PRODUCT CHANGE NOTIFICATION (PCN)

PCN #: Telink-PCN-2023-0005-Update		Date: 2023/01/13
Classification of Chang:	Chang Impact on product:	Customer Notification:
<input checked="" type="checkbox"/> Critical <input type="checkbox"/> Major <input type="checkbox"/> Minor	Function <input checked="" type="checkbox"/> No <input type="checkbox"/> Yes Form <input checked="" type="checkbox"/> No <input type="checkbox"/> Yes Fit <input checked="" type="checkbox"/> No <input type="checkbox"/> Yes Quality or Reliability <input checked="" type="checkbox"/> No <input type="checkbox"/> Yes	<input checked="" type="checkbox"/> Approval Required <input type="checkbox"/> Information Only
Device affected: TLSR8359F512ET32		
Shipment affected: Not affected.		
Last time order(optional): NA		Final shipment date(optional): NA

Subject: Add embedded flash P25D40SL (40nm) / P25D40SU (40nm) from supplier Puya for device TLSR8359F512ET32.

Marking and Label sample:

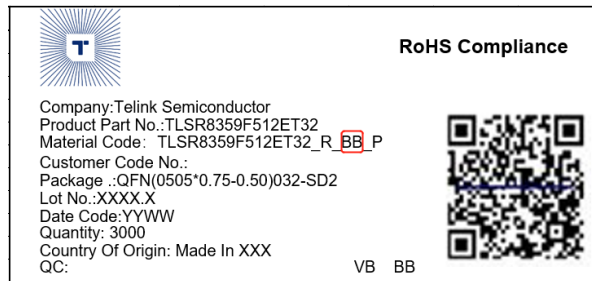
P25D40SL:

- The characters of "BB" in the 3rd line of marking stands for flash P25D40SL.
- Material code in the label is TLSR8359F512ET32_R_BB_P

Marking and Label sample:

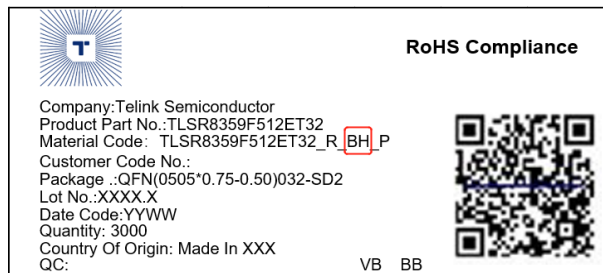
P25D40SU:

- The characters of "BH" in the 3rd line of marking stands for flash P25D40SU.
- Material code in the label is TLSR8359F512ET32_R_BH_P
